CITY OF ALBUQUERQUE

RE: **Volcano Cliffs Unit 5 lot 12 block 7 SAD 227**
7908 Emerald Dr. NW
Grading and Drainage Plan
Engineers Stamp Date; 8/28/2023 (E10D126)
Pad Certification Date; 10/19/2023

DRAINAGE AND TRANSPORTATION INFORMATION SHEET (REV 6/2018)

ENGINEER'S SEAL DAVID SOULE P.E. #14522	LOT 12 BLK 11 UN 5 VC 7908 EMERALD DR.	DRAWN BY DEM
	GRADING AND DRAINAGE PLAN	DATE 8-26-23
 P.O. BOX 53924 ALBUQUERQUE, NM 87199 (505) 321-9099	SHEET # C1	JOB #

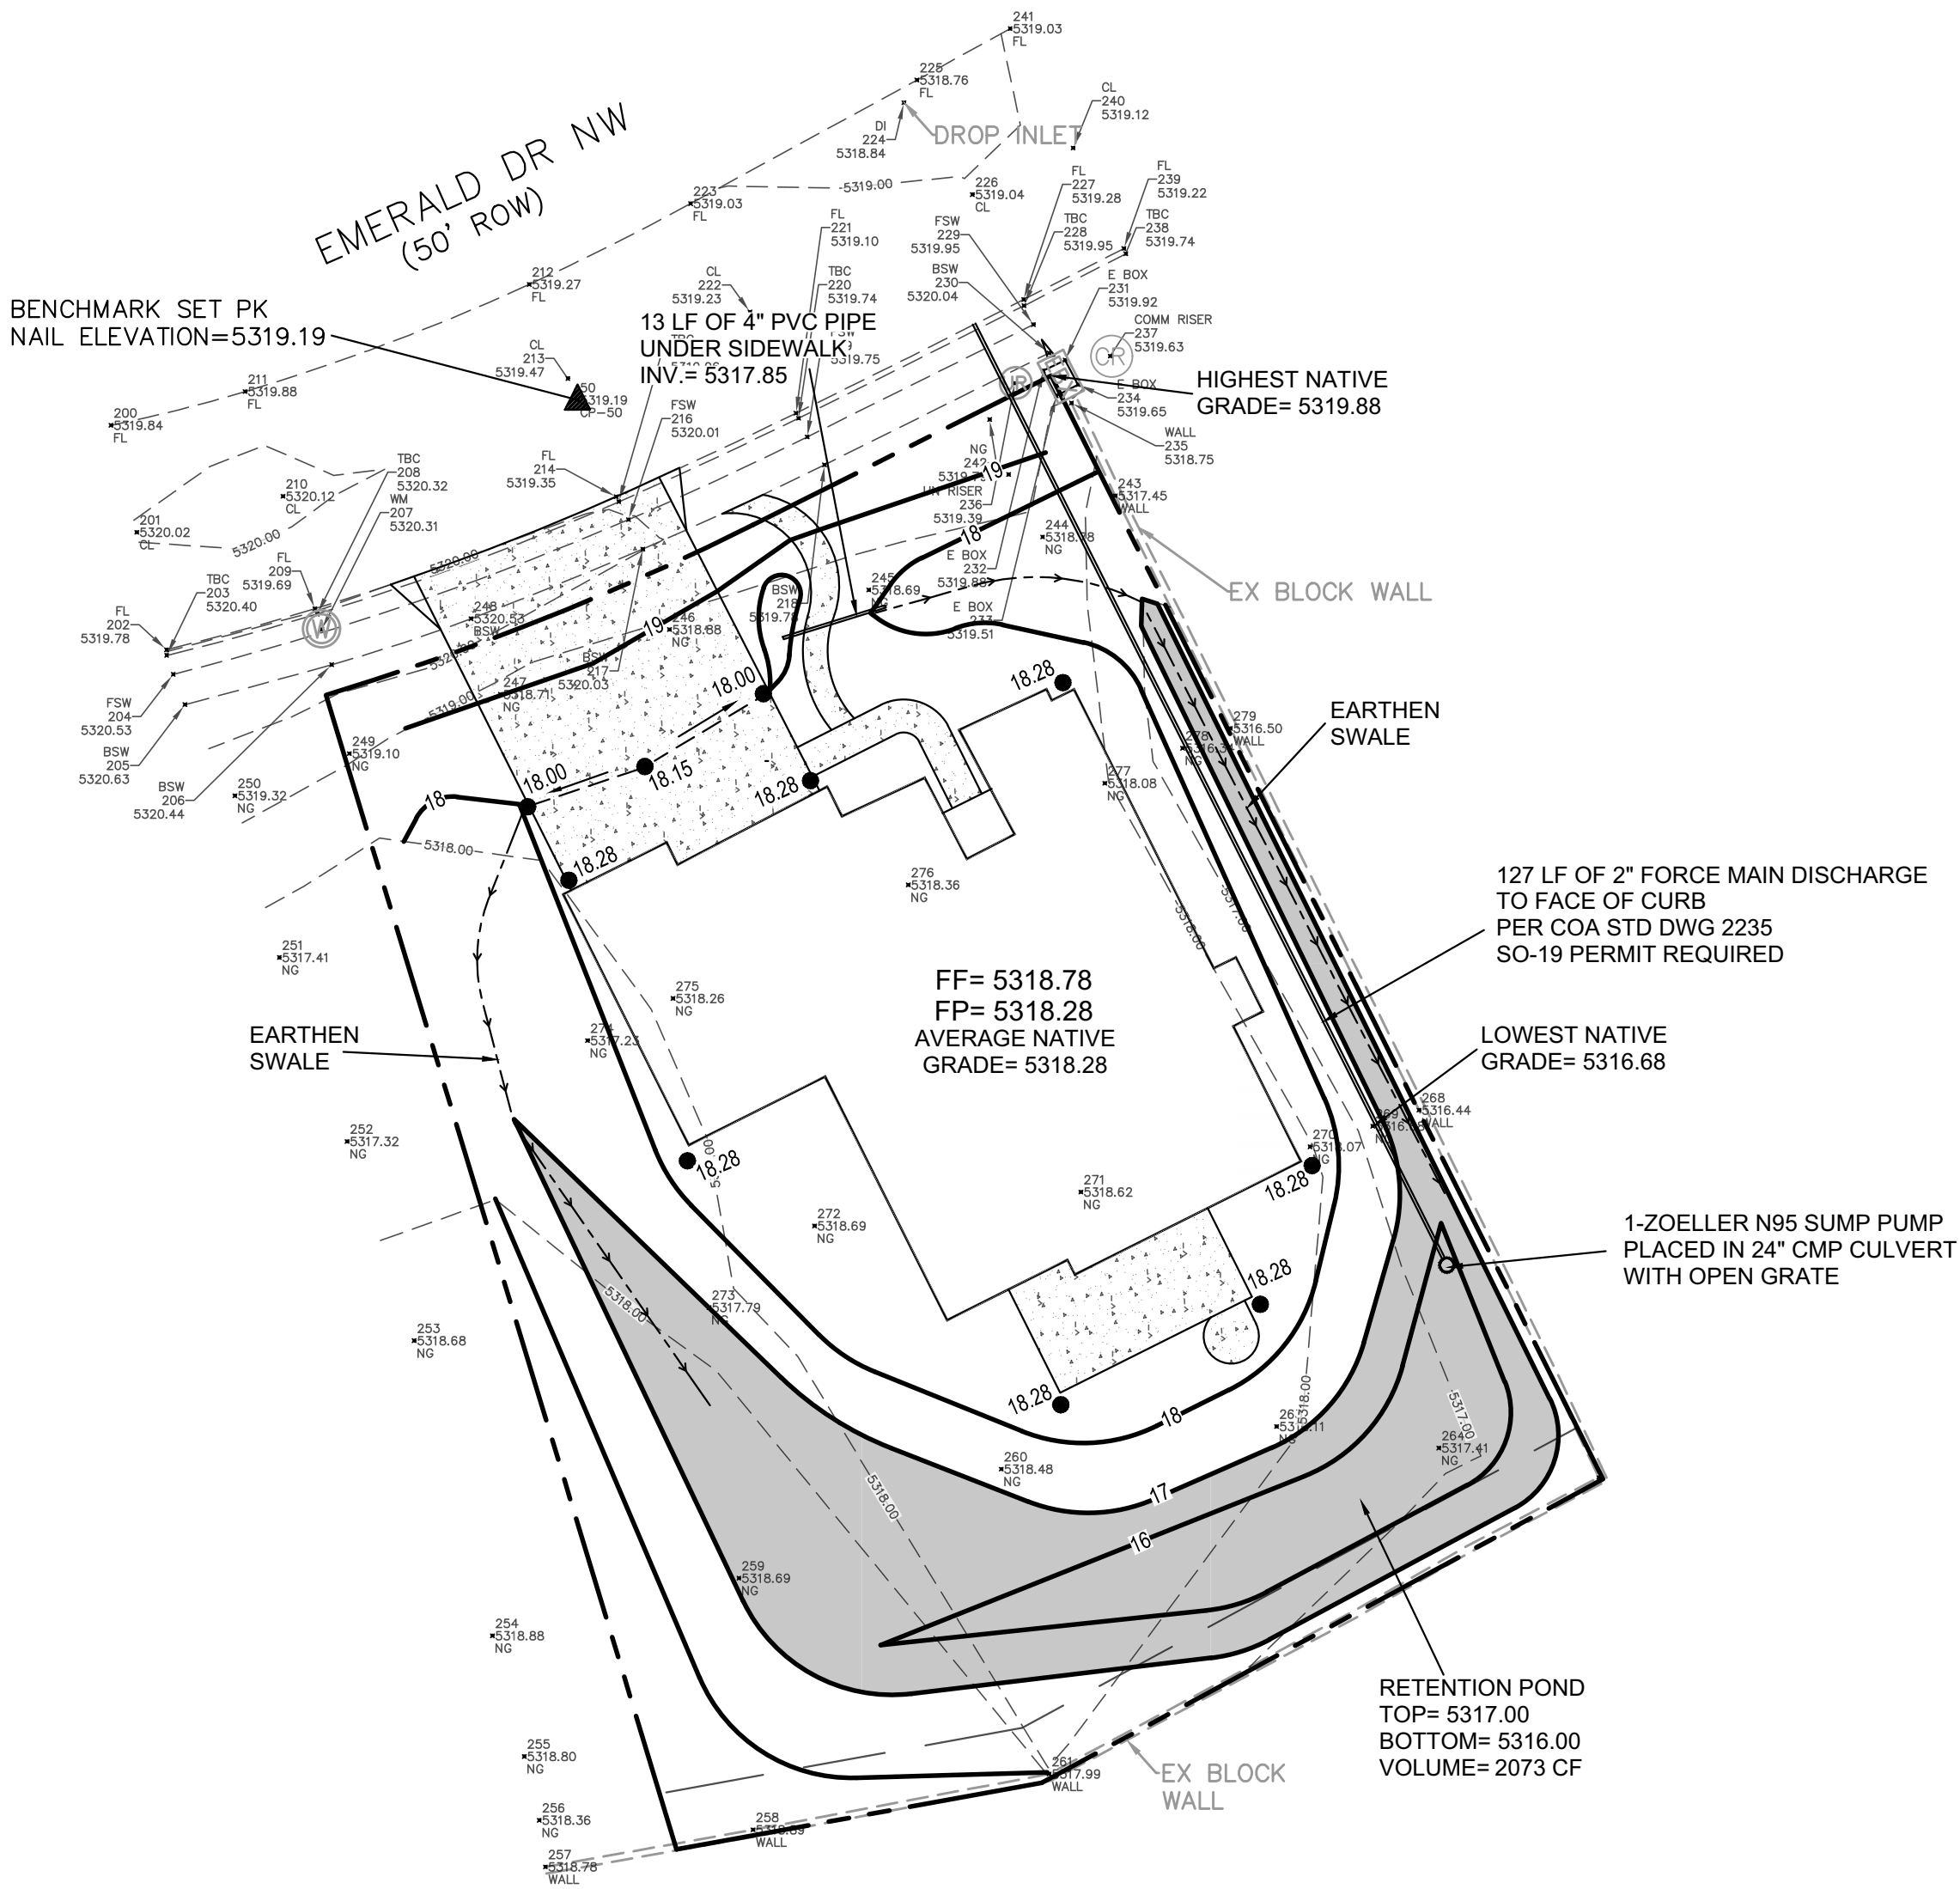
Based upon the information provided in your submittal received 10/19/2023, this plan is approved for Building permit.

Albuquerque **Reiterate to the Owner/Contractor that a separate permit for a garden/retaining wall must be obtained, with the approved G&D plan and Pad Certification. Inform the owner & Contractor that dirt is not allowed in the public right of way to climb the curb. Crusher fines or lumber are allowed. If dirt is used this will delay the permitting process.**

NM 87103 Prior to Certificate of Occupancy release, Engineer Certification per the DPM checklist of this plan will be required.
